BULLETIN SER 73 S-2

Title: EXCESSIVE CLUTCH NOISE

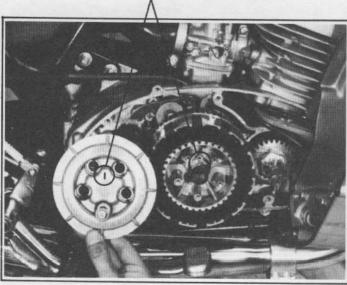
Some of the early S2 units may develop a rattling sound which seems to come from the right engine cover. The noise is most noticeable with the transmission in neutral, clutch hand lever released. When the hand lever is pulled, the rattling sound is eliminated. Usually, the noise is not present in a new unit, but develops within the first 500 miles of driving, if it occurs at all.

The rattling noise is evidence of excessive clearance between the clutch housing drive fingers and the driven tabs on the friction plates. Slight variations in the clutch housing RPM resulting from engine firing impulses cause the housing to speed up and slow down slightly, and the tabs of the friction plates, held together by the clutch spring, are struck on one side (load) and then the other side (coast) by the housing fingers. Standard clearance between the fingers and the tabs is 0.002-0.022" (0.05-0.555 mm). As the clearance exceeds 0.010" (0.25mm), however, clutch rattle becomes more evident.

To take up the excessive clearance, Kawasaki has prepared clutch finger shims. Three shims are needed to repair one clutch.

To install the shims, drain the oil and take off the right engine cover. Remove the pressure plate bolts and springs, and then take off the pressure plate and pull the clutch plate "pack". Install the three shims as shown here, at 120° intervals, or 4 fingers apart. IM-PORTANT: The shims must be installed on the "coast" side of the clutch housing finger. NOTE: Make sure the three shims are all the same thickness.
